report group: Playground Inspection  
title: 17902 Hawk Haven Ln.  
created: 12/20/22, 9:59 AM  
modified: 12/21/22, 10:26 AM  
item count: 29

report group: Compliant Park Inspection  
title: 17902 Hawk Haven Ln.  
created: 3/10/23, 9:25 AM  
modified: 3/21/23, 7:04 AM  
item count: 17

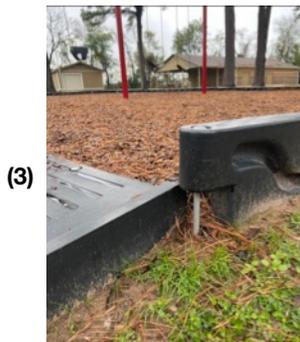
created: 12/20/22, 10:02 AM  
modified: 12/20/22, 10:29 AM  
taken by app: Yes  
description: Playground  
36' diameter  
18' radius

Scope of the playground safety inspection:  
the play equipment was inspected against the current CPSC public playground Safety Handbook and ASTM F1487-17. Any equipment that was not in compliance will be reported in this inspection report and the standard will be cited. Any items that the inspector found to be in compliance but that may need to be monitored will also be noted.

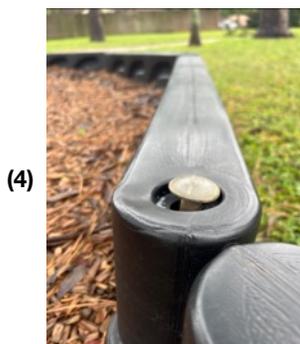
created: 12/20/22, 10:03 AM  
modified: 12/20/22, 10:03 AM  
taken by app: Yes  
description: Ground level entanglement hazard

ASTM F1487 6.4  
-there shall be no entanglement hazards on public play equipment.

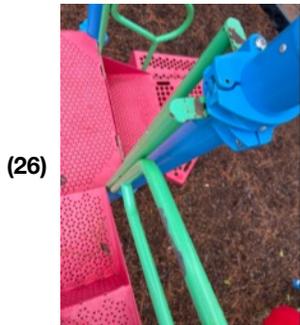
created: 12/20/22, 10:52 AM  
modified: 12/20/22, 10:52 AM  
taken by app: Yes  
description: Main entry/staircase unstable, broke MUST be addressed asap

[ASTM F1487 7.1.1](#)

-accessible routes within a use zone shall conform to the performance requirements of specifications F1292 and F1951.

(5)  **created:** 3/10/23, 9:27 AM  
**modified:** 3/17/23, 9:22 AM  
**taken by app:** Yes  
**description:** Access to first entry step has been restablized with a new footer and proper hardware.

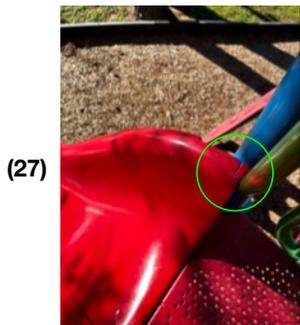
created: 12/20/22, 10:54 AM  
modified: 12/20/22, 10:54 AM  
taken by app: Yes  
description: Paint flaking/chipping

[CPSC 2.5.4](#)

-Paint and other finishes should be maintained to prevent rusting of exposed metals and to minimize children playing with peeling paint and paint flakes.

created: 3/10/23, 9:32 AM  
modified: 3/17/23, 9:26 AM  
taken by app: Yes  
description: Painted playground sets free of flaking paint.

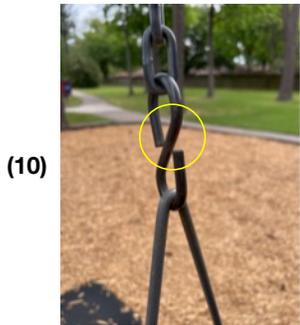
created: 12/20/22, 10:35 AM  
modified: 12/20/22, 10:35 AM  
taken by app: Yes  
description: Tripping/entanglement hazard  
along playground border  
- at least 20+ locations of this  
problem

[CPSC 3.6 Tripping Hazard](#)

-play areas should be free of tripping hazards to children who are using a playground. two common causes of tripping are anchoring devices for playground equipment and containment walls for loose fill surfacing materials

(8)  **created:** 3/10/23, 9:30 AM  
**modified:** 3/17/23, 9:24 AM  
**taken by app:** Yes  
**description:** Border filler added removing entanglement hazard.
